OBJECTIONS AND COMMENTS ON DA 2023/1832

**By Robert Story and Susan Duncan, additional to Helen Monks,
Town Planner**

5 PORTIONS, LOVETT BAY NSW

DRG-03
TOWER LOOK OVER DUNCAN
HOUSE

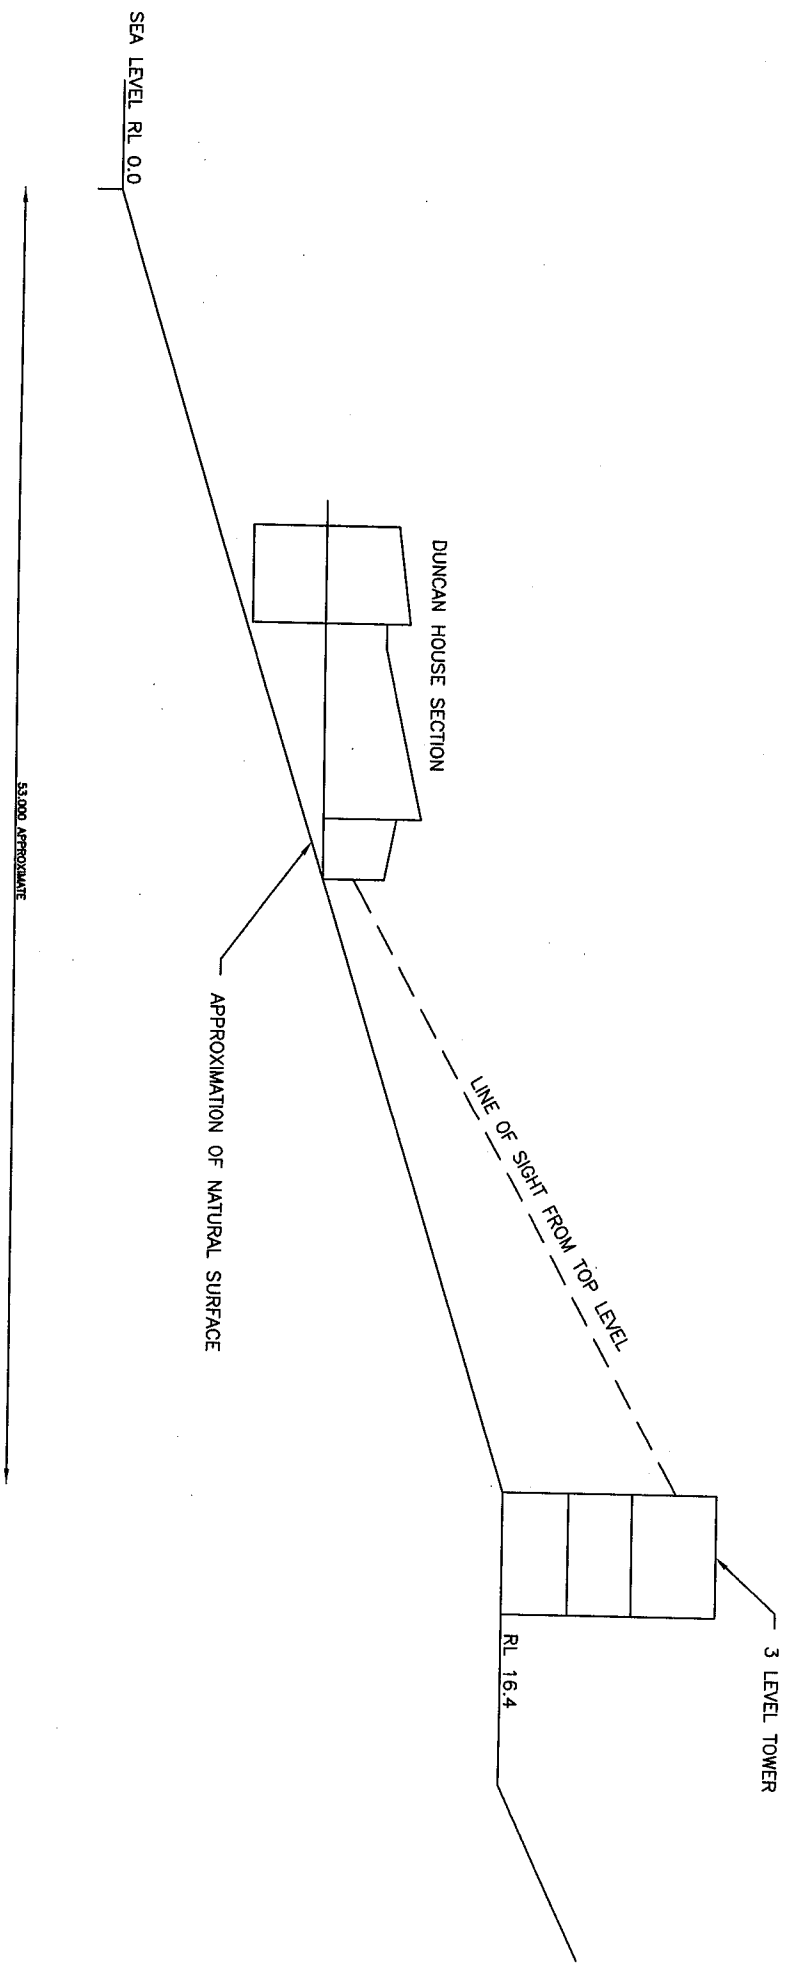
3. 5 Portions site is subject to high moisture content especially in heavy rains resulting in intermittent and semi-permanent springs.
4. Geotech report misrepresents the steepness of the site and the problems with water run-off.
5. Shadow lines are grossly understated and need to be reinvestigated. The shadow of the house would come to the back door of 3 Portions, which means that main building and the tower would dominate the view from that position.

DRG-04
ACTUAL SLOPE

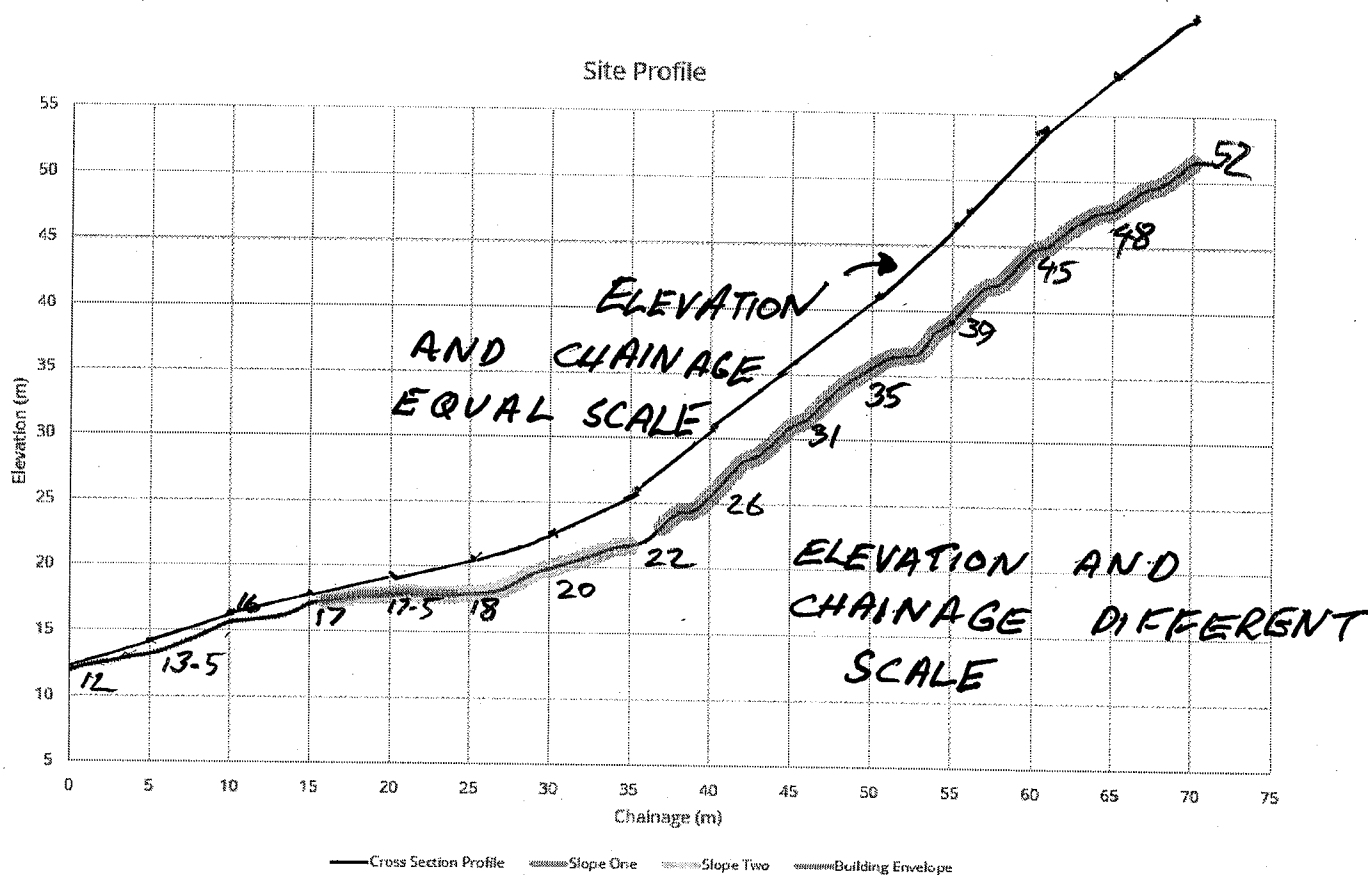
Figure 3.1 profile cross-section is misleading. The elevation and chainage are different scales, giving a shallower appearance of the slope of the land.

Refer to DRG-04 The block is steeply sloping from the water's edge, starting at 20 degrees and increasing to 45 degrees.

There are several horizontal benches or terraces cut into this slope but they do not affect the overall steepness of the block.

DRG-05 BOUNDARY ERROR
APPENDIX A

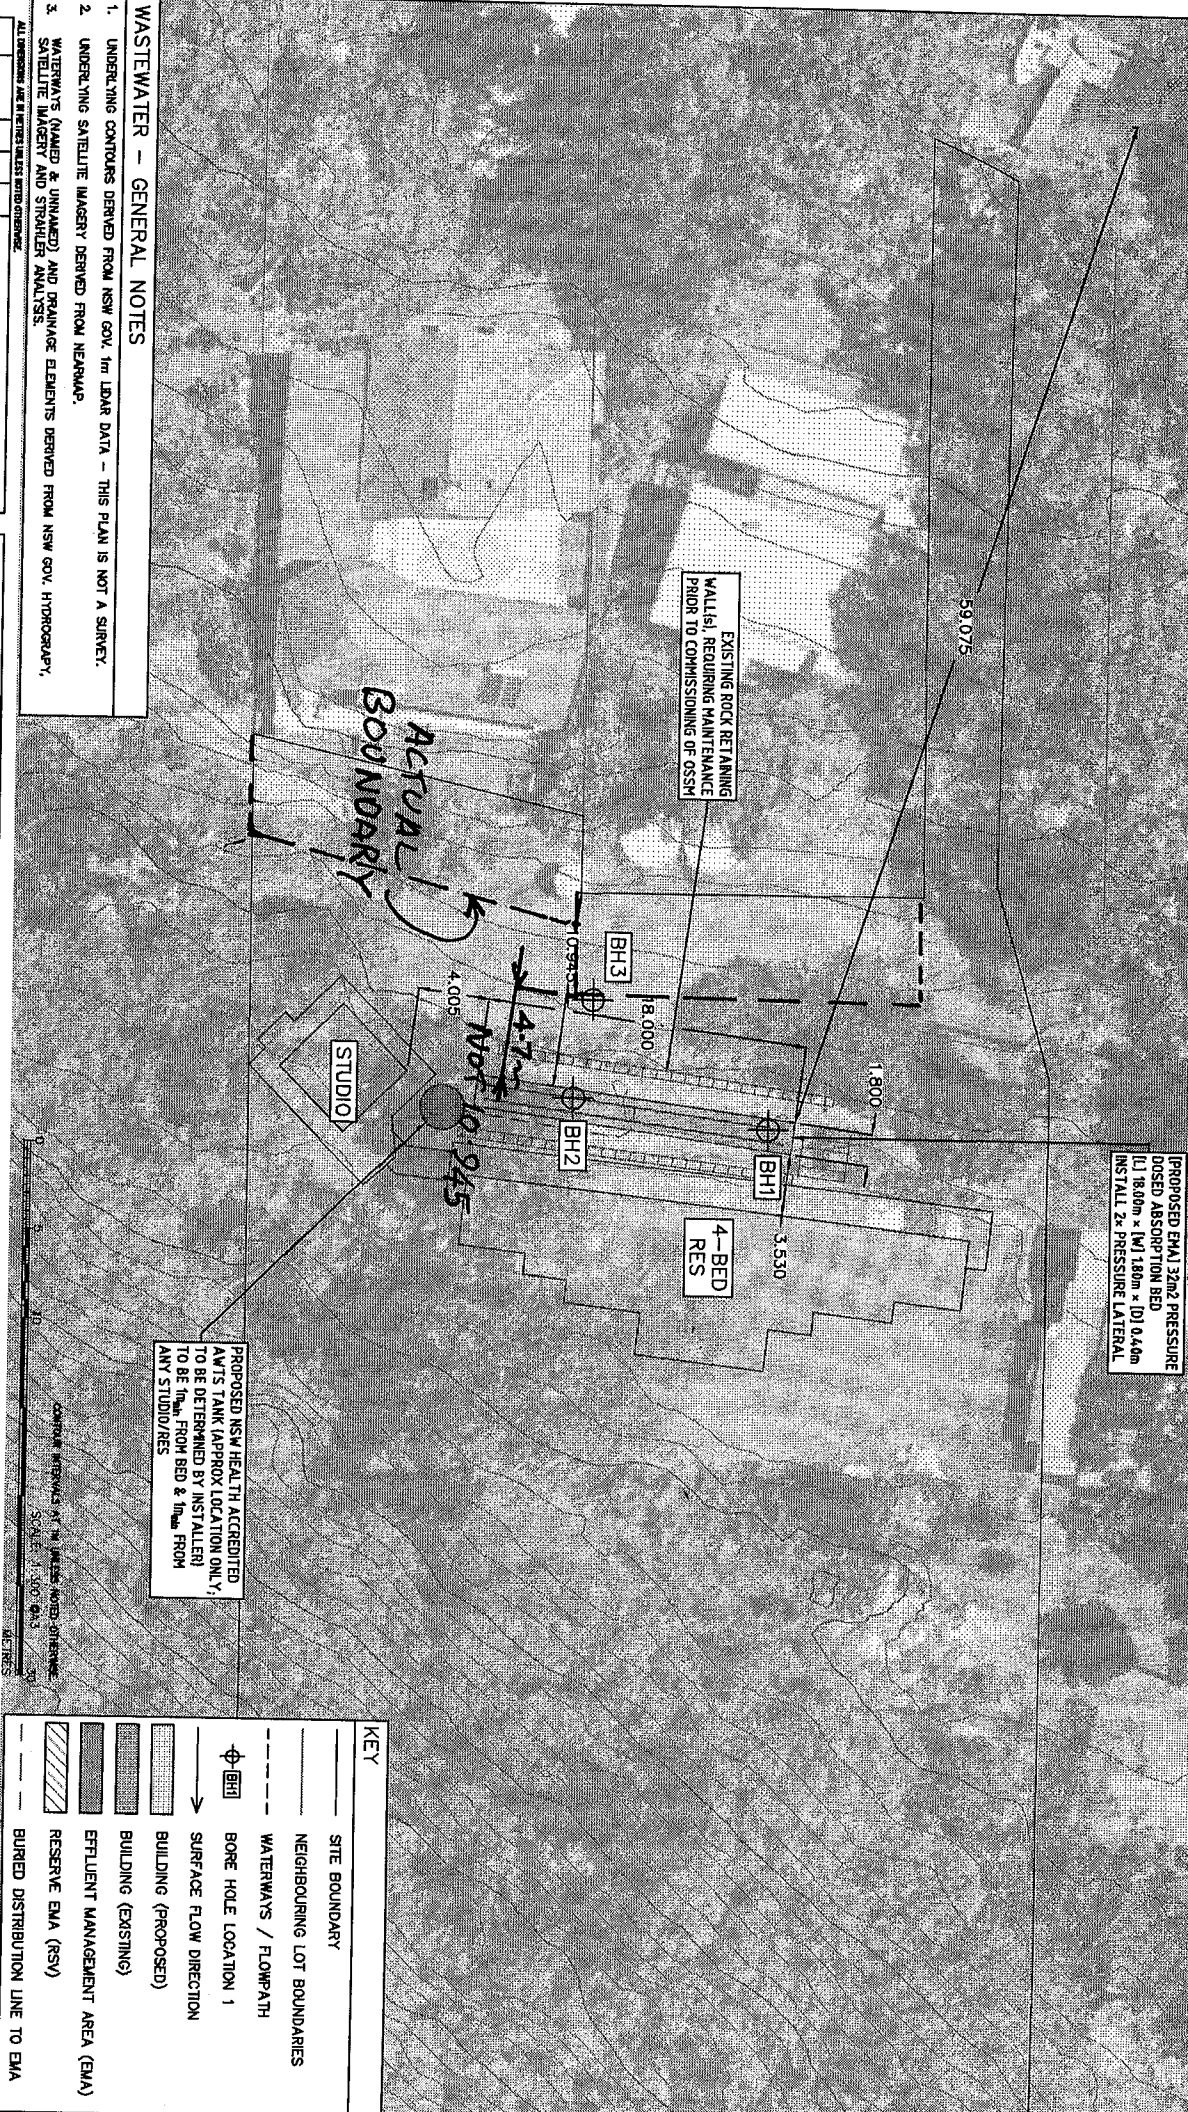
E Position of land application area in landscape: boundaries are incorrectly shown on Appendix 1 and are out by a distance of **7 meters**.

Appendix 1: Boundaries of Lot 3 and Lot 6 incorrectly drawn and show a major discrepancy of 7 meters. See drawings 5 & 6.

1. EMA is far too close to 3 Portions boundary and must be located at least 12 meters off this boundary.
2. Appendix 1 of the wastewater report shows the Portion 3 property boundary to be approximately 7 metres south of the actual location.

DRG-07 SHADOW LINE

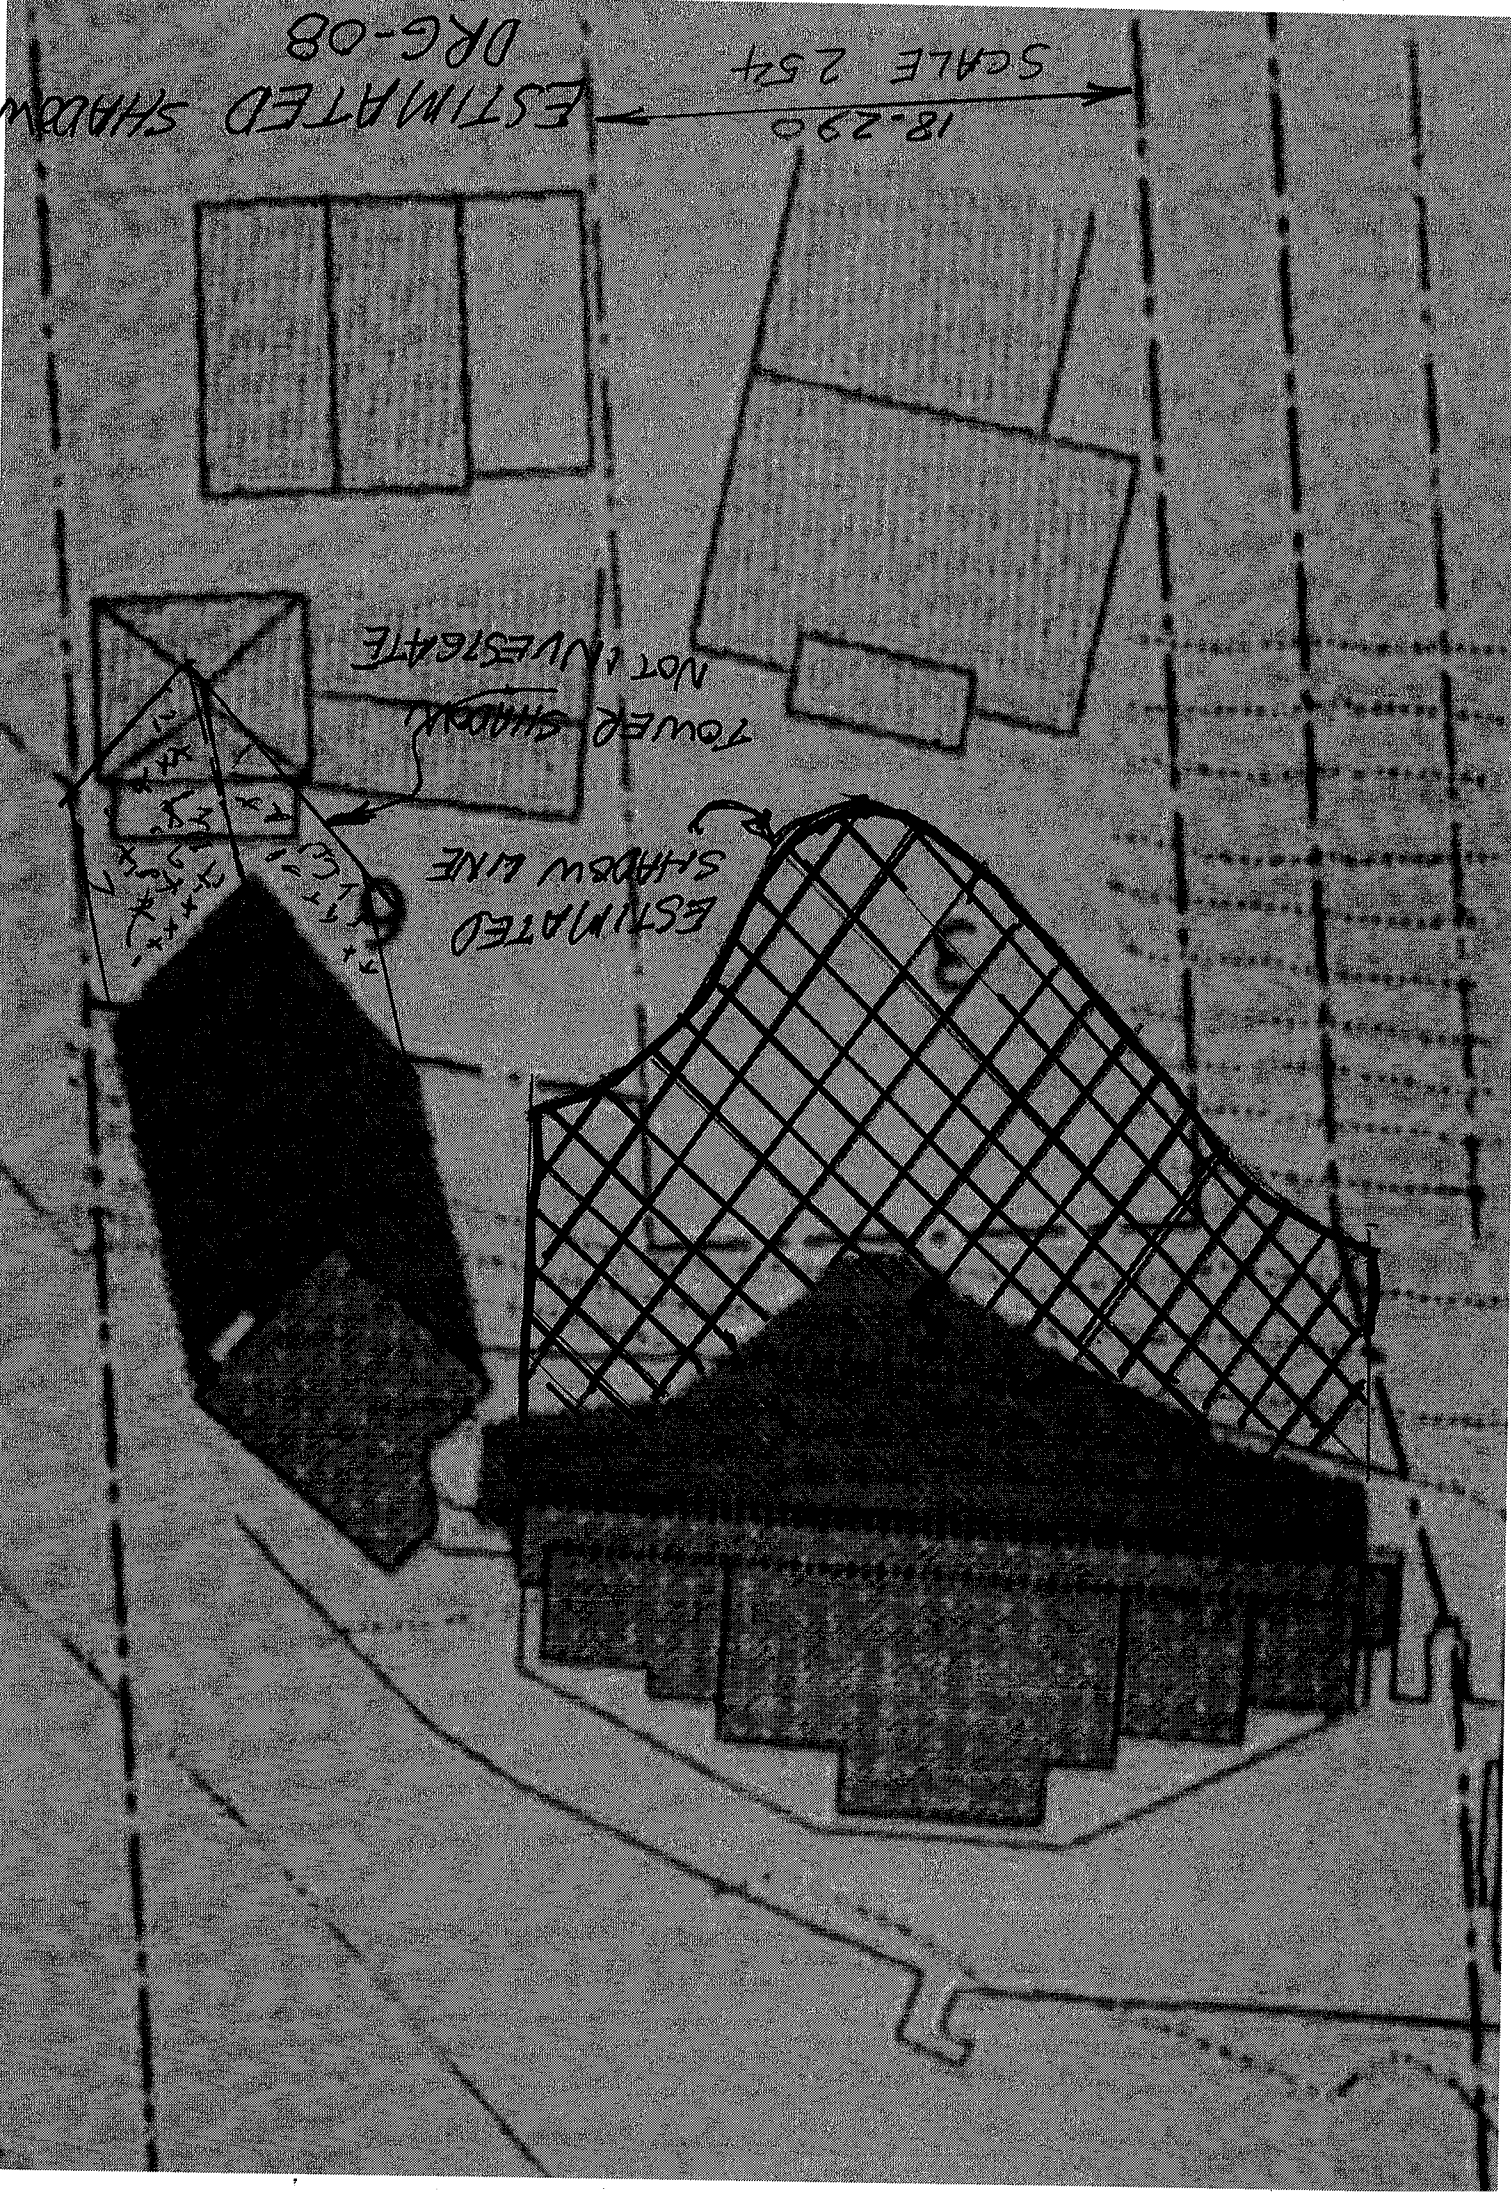
There is a fundamental error in the shadow lines provided. *See DRG 01, 07,08.*

Analysis does not take into account that the land between 5 Portions and 3 Portions, falls steeply away at around 20 degrees. The shadow lines chase the sloping land until the shadow line catches up. Shadow length is around 11 metres, whereas I have calculated a shadow of approximately 25 metres. **See DRG 07.**

We can argue the correct shadow length, but the simplest solution is to carry out a site measurement. A theodolite can be set up at the Duncan House to sight a measuring staff at the Leplastrier designed building at the front elevation. Knowing the distance and the angle, an accurate drawing can be compiled. **See DRG -07.** No surveyor is required as I have a theodolite and can do a full and accurate check with a representative of the Leplastrier family.
